project:	architect:	in association with:	title:
SOP 53 2 FIGTREE DRIVE SYDNEY OLYMPIC PARK <small>Copyright of the design and other information shown here is owned by Mirvac Design Pty. Ltd. Reproduction or use of the design by any party for any purpose is expressly forbidden without the written permission of Mirvac Design Pty. Ltd. Mircac Design Nominated Architect Diana Saraceno NSW 6025 VIC 3066 QLD 3091 WA 2902</small>	Mirvac Design <small>architects planners interior designers</small> Level 28, 200 George St. Sydney NSW 2000 Tel: 02 9090 8000 Fax: 02 9080 8181 Mirvac Design Pty. Ltd ABN 78 003 339 623	mirvac <small>Telephone +61 2 8297 7200 Facsimile +61 2 8297 7299 www.mirvac.com.au</small>	COVER SHEET

COVER SHEET

- MODIFICATION TO SSD 7662**
- BUILDING 1**
- 1a. Mechanical louvers and retail facade amended on basement 1
 - 1b. Main pedestrian entry for Building 1 & 2 from Figtree Drive to L1 landscape podium updated

title:
**GENERAL ARRANGEMENT
PLAN - LEVEL 05**

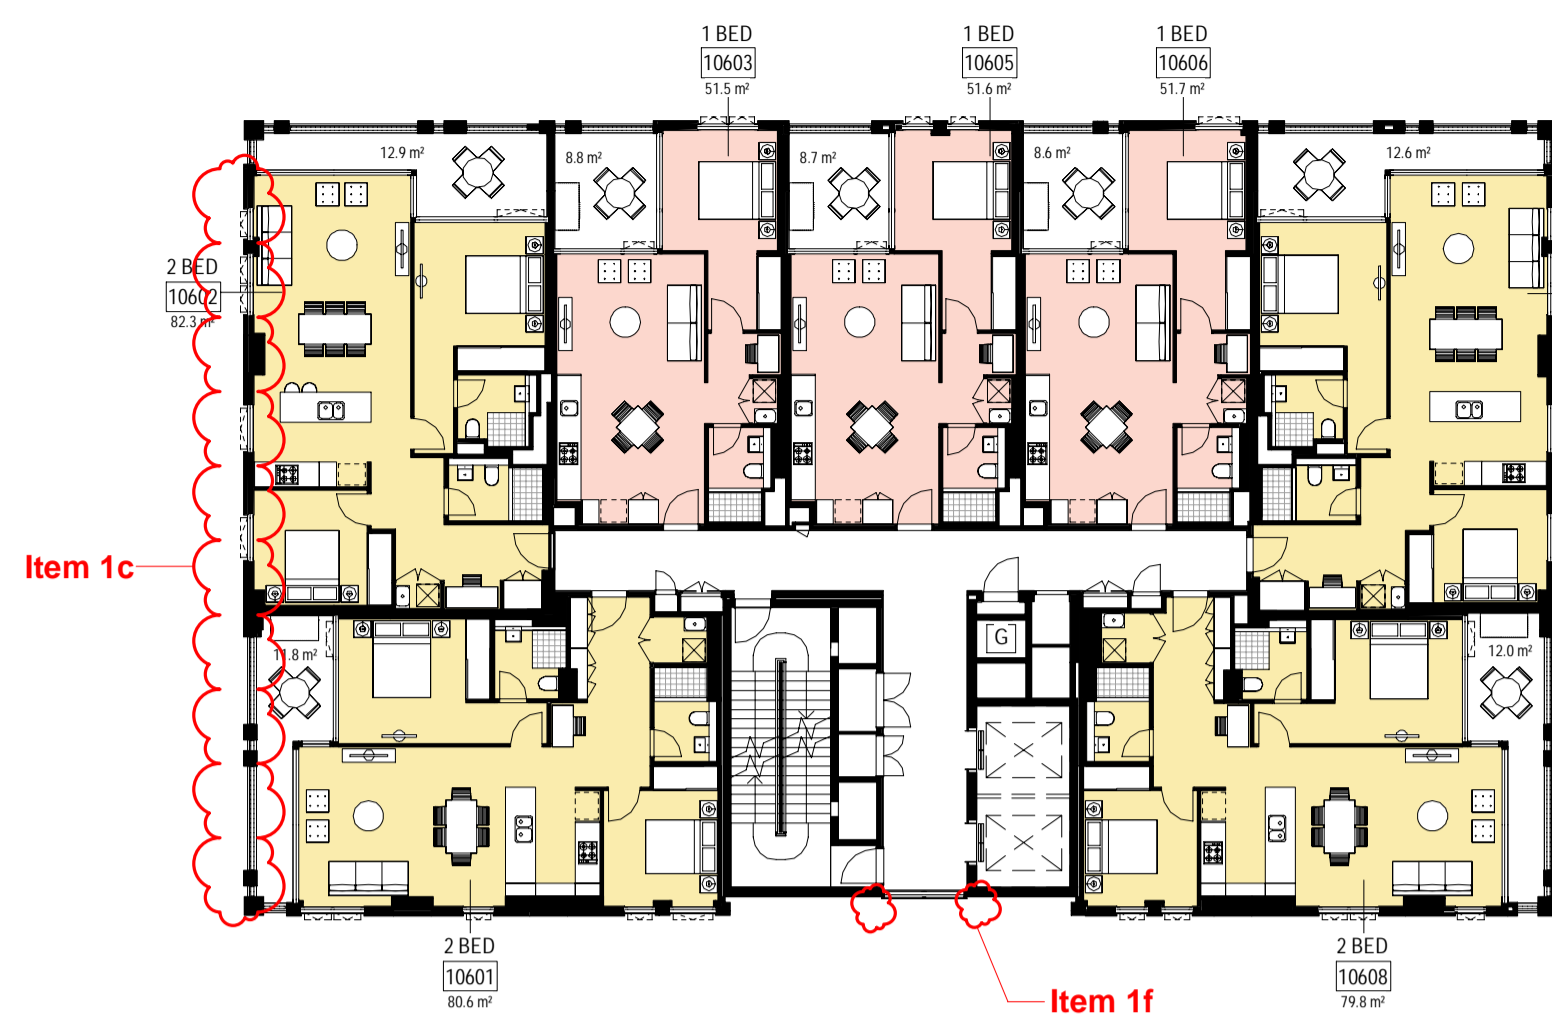
- MODIFICATION TO SSD 7662**
- BUILDING 1**
- 1a. Mechanical louvers and retail facade amended on basement 1
 - 1b. Main pedestrian entry for Building 1 & 2 from Figtree Drive to L1 landscape podium updated

- 1c. Privacy screen relocated to Building 5 from Building 1 (L3 to L8)
 - 1d. Roof screen & lift overrun area revised
 - 1e. Off form concrete to terraces entry portal on L1

- 2c. Louvered roof removed & plant room area updated on L25
 - 2d. Plant room screen & top of lift machine room updated on L36
 - 2e. Glazing opening added to the side blade wall on L25 to improve amenity of apartment

- 2f. Windows location in apartment updated on L35
 - 2g. Plant room screen added to the back of core on L1 to L16
- BUILDING 3**
- 3a. Awning above the entry of gym room added on L1

- 3b. Awning above substation added
 - 3c. Roof plant screen & plant area amended on L10
 - 3d. Gym/Yoga Studio & Community Room location swapped on L1
 - 3e. Courtyard to apartment added on L1

- 3f. Balcony in apartment updated on L8
 - 3g. Roof plant screen reduced on L8
- BUILDING 5**
- 4a. Privacy screen relocated to Building 5 from Building 1 (L4 to L8)

- 4e. Conversion of 2 Bed to 1 Bed & Security Office on L1
 - 4f. Conversion of 2 x 3 Bed to Communal Recreation Space & Leasing Office on L9
 - 4g. Plant room area relocated and louvered roof removed on L25

- 4h. Courtyard to apartment added on L1
 - 4i. Off form concrete to terraces entry portal on L1
 - 4j. Inclusion of workshop/storage in bicycle storage on L1

- 4k. Facade amended to suit approved DA floor plan
- BASEMENT**
- 5a. Relocation of car parking spaces in basement levels
 - 5b. Basement outline amended

- 5c. Main switch room relocated to B2
 - 5d. Cold water plantroom relocated to B1
 - 5e. Bicycle storage / parking added to B1
 - 5f. Parcel locker area added to B1

title:
**GENERAL ARRANGEMENT
PLAN - LEVEL 09**

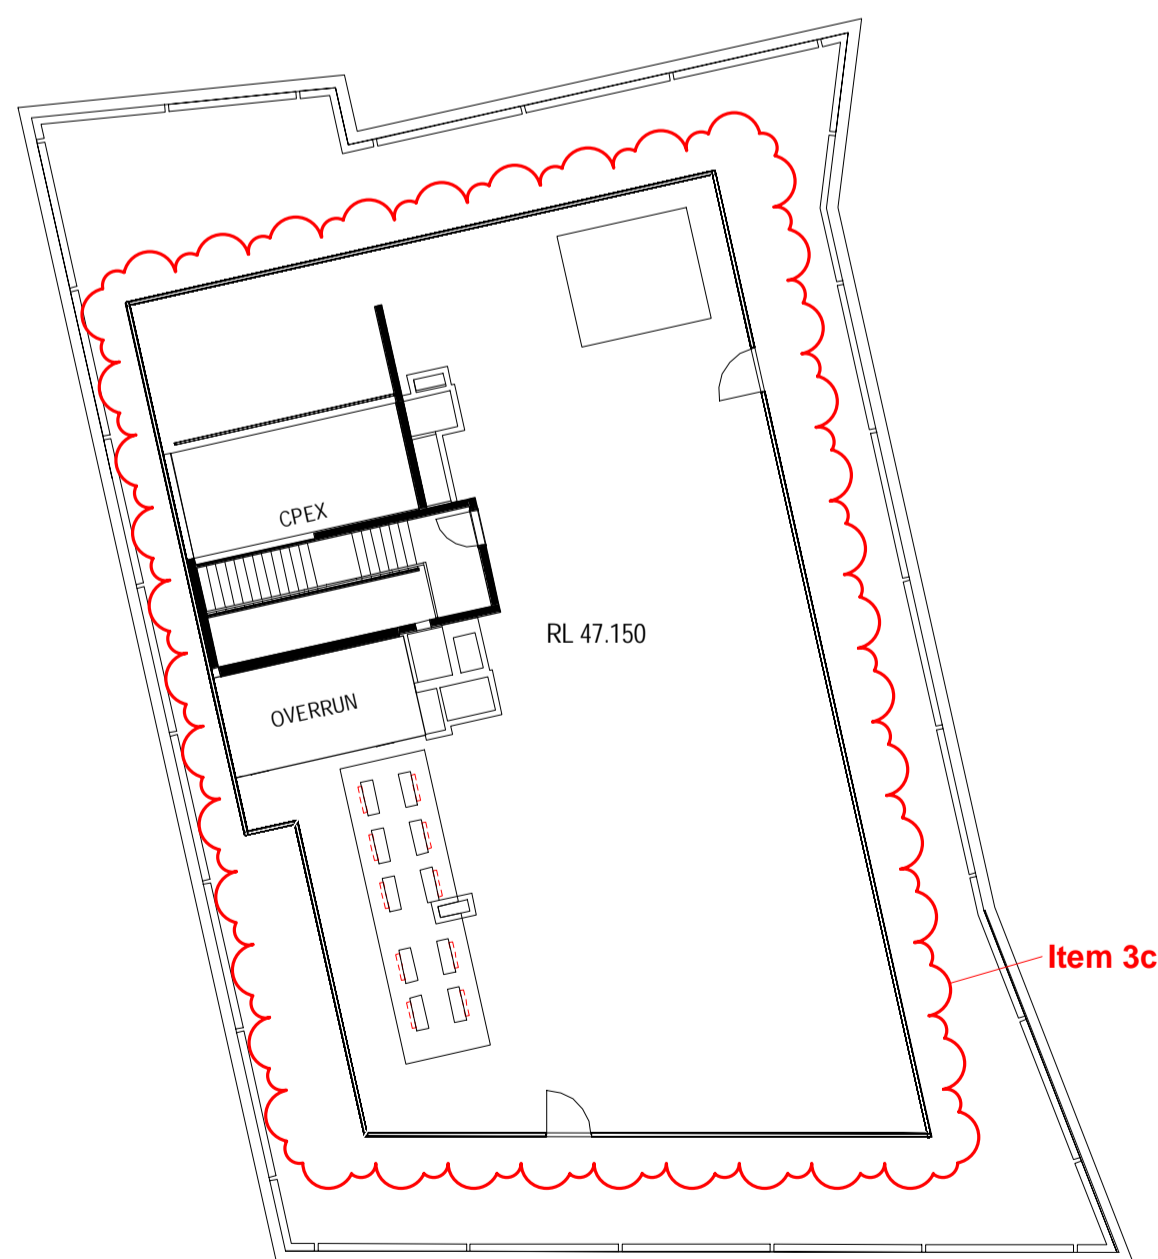
- MODIFICATION TO SSD 7662**
- BUILDING 1**
- Mechanical louvers and retail facade amended on basement 1
 - Main pedestrian entry for Building 1 & 2 from Figtree Drive to L1 landscape podium updated

- Privacy screen relocated to Building 5 from Building 1 (L3 to L8)
 - Roof screen & lift overrun area revised
 - Off form concrete to terraces entry portal on L1

- Louvered roof removed & plant room area updated on L25
 - Plant room screen & top of lift machine room updated on L36
 - Glazing opening added to the side blade wall on L25 to improve amenity of apartment

- Windows location in apartment updated on L35
 - Plant room screen added to the back of core on L1 to L16
- BUILDING 3**
- Awning above the entry of gym room added on L1

- Awning above substation added
 - Roof plant screen & plant area amended on L10
 - Gym/Yoga Studio & Community Room location swapped on L1
 - Courtyard to apartment added on L1

- Balcony in apartment updated on L8
 - Roof plant screen reduced on L8
- BUILDING 5**
- Privacy screen relocated to Building 5 from Building 1 (L4 to L8)

- Conversion of 2 Bed to 1 Bed & Security Office on L1
 - Conversion of 2 x 3 Bed to Communal Recreation Space & Leasing Office on L9
 - Plant room area relocated and louvered roof removed on L25

- Courtyard to apartment added on L1
 - Off form concrete to terraces entry portal on L1
 - Inclusion of workshop/storage in bicycle storage on L1
 - Facade amended to suit approved DA floor plan

- BASEMENT**
- Relocation of car parking spaces in basement levels
 - Basement outline amended
 - Main switch room relocated to B2
 - Cold water plantroom relocated to B1

- Bicycle storage / parking added to B1
 - Parcel locker area added to B1
